LICENSING TOPICAL REPORT

QUALIFICATION OF THE ONE-DIMENSIONAL CORE TRANSIENT MODEL FOR BOILING WATER REACTORS VOLUME 1

SUBJECT: ACCEPTANCE FOR REFERENCING GENERAL ELECTRIC LICENSING TOPICAL
REPORT NEDO-24154/NEDE-24154P

Figure 4-13. Valve Flow Control Block Diagram

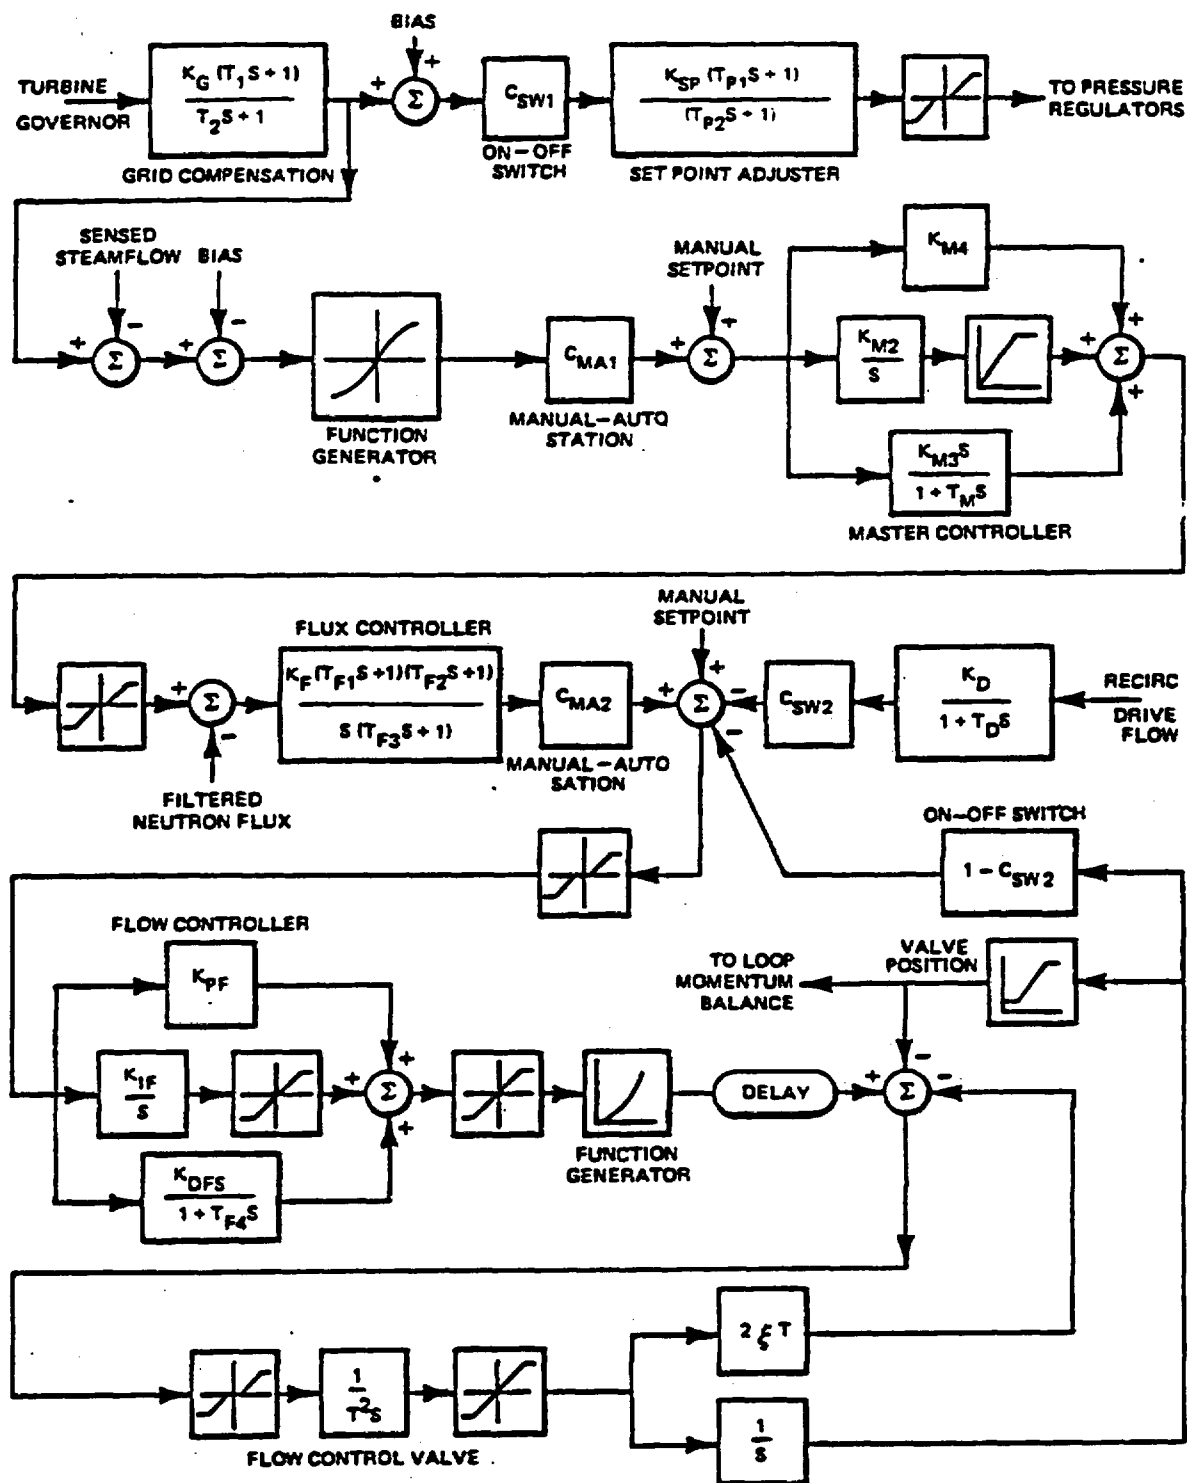
Figure 4-13 provides a block diagram of the valve flow control. Additional description of the control system is required to complete our review of the block diagram. In this regard, provide the following information:

The block entitled, "Grid Compensation Function" in the block diagram (Figure 4-13) is a lead/lag function, the time constants of which are approximately the inverse of the lag/lead function in the pressure regulator. Its purpose is to give the load following loop lead effect to compensate for the lag effect inherent in the pressure regulator. Gain K_G is determined by calculation and verified experimentally both in the field and on the computer.

Figure 18-1. OLYN Pressure Nodal Diagram

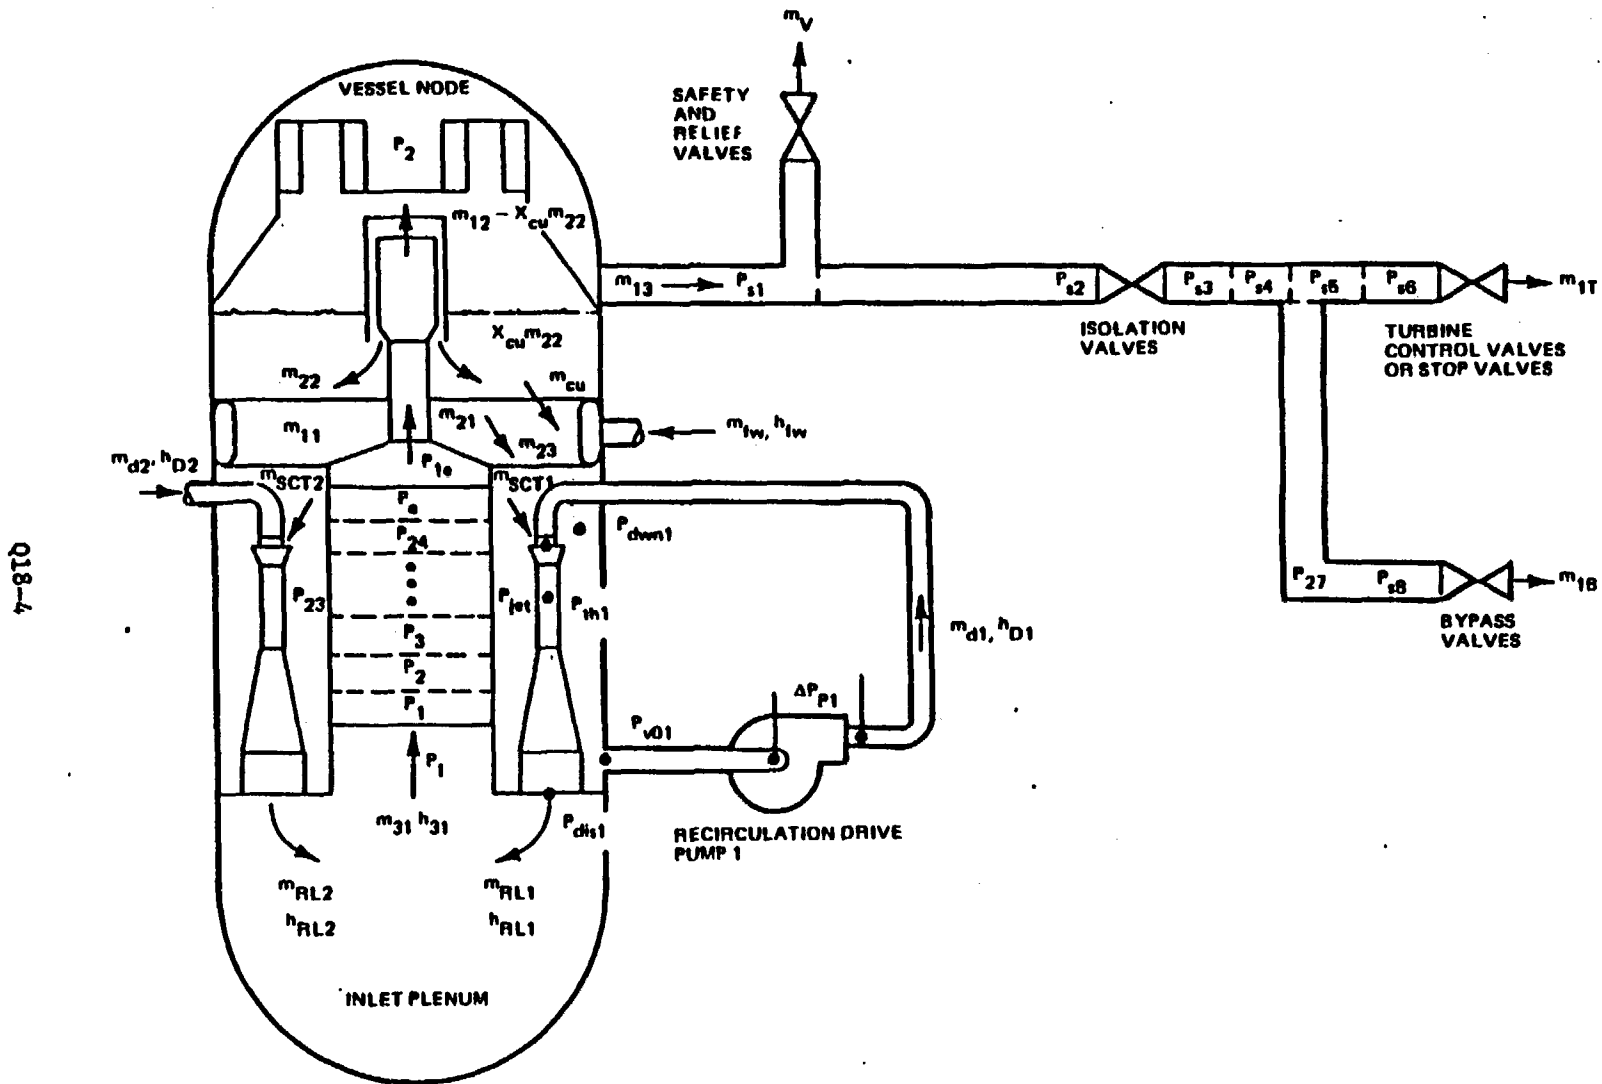
Figure 4-1 is insufficient to derive Equations 4-35 through 4-40. Draw the proper figures in detail, indicating the meaning of all symbols on the figures.

The attached nodalization diagram (Figure 18-1) indicates the pressure nodes in the ODYN model. Note that the core is nodalized axially as is the steamline.

The justification for this choice of nodes is based on several factors, the most important of which are: (1) the variation of fluid or material properties is negligible over the region; (2) the fluid flowing in the recirculation system is liquid, subcooled and quite incompressible so that acceleration of the flow occurs as a single inertial unit (integral momentum); (3) wave type phenomena demonstrate wave lengths much longer than the nodes; (4) adequate approximation to the phenomena based on the modal representation of a region is made; and (5) the transient pressure drops do not result in significant changes in the approximations (2) through (4) above.

The basis for choosing a single node in the vessel dome is that the pressure drop from the downcomer inlet to the top of the dome is nearly all due to density effects. This amounts to 5 to 6 psi difference from bottom of the dome region to the top. Compared with operating pressures of typically 1000 psia or greater, the difference above results in less than 0.5% change in fluid properties in the dome region. In addition, the dome region is a very large area compared to the height (very little inertial effect). Hence, there is no observable wave response in the dome region. Finally, since the acoustical velocity in steam is ~1500 ft/sec, the change of pressure within the dome is effectively instantaneous whenever a flow disturbance is introduced into the reactor vessel.

In the downcomer region during the pressurization transients, the recirculation flow is subcooled by about 20 Btu/lbm. With this degree of subcooling, the change in liquid properties is very small due to pressure. The pressure change from the dome to the bottom of the reactor vessel is about 35 psi, most of which is due to density head and the jet pump diffuser pressure increase. Since the pressure in the downcomer and core inlet is about 1000 psia or greater, the fluid properties vary by less than 0.1%, which is negligible as in the dome region. In addition, sonic speed is in the range of a few thousand feet per second in the downcomer and lower plenum region, which means that similar to the dome region the downcomer and inlet plenum respond to pressure disturbances in the reactor vessel almost instantaneously. This does not mean, however, that flow rate responds instantly to equilibrate pressure disturbance effects, because the recirculation system will require an additional amount of time for fluid acceleration around the loop.

The core is not represented as a single node for pressure calculations in ODYN. The equations in Section 6 require nodal calculation in the core for pressure, density, enthalpy and flowrate. If reference is made to Figure 4-7 (Jet Pump Schematic), please note that the ΔP_{core} is indicated without the nodal structure and P_e , the core exit pressure, is indicated, which may leave the impression that a single pressure is used to represent the core. However, this is not the case as seen by implication from Section 6. The core inlet orifice pressure drop is about 10 psi and is taken into account in the ODYN core. The total core pressure drop is typically 20-25 psi, including the inlet orifice.
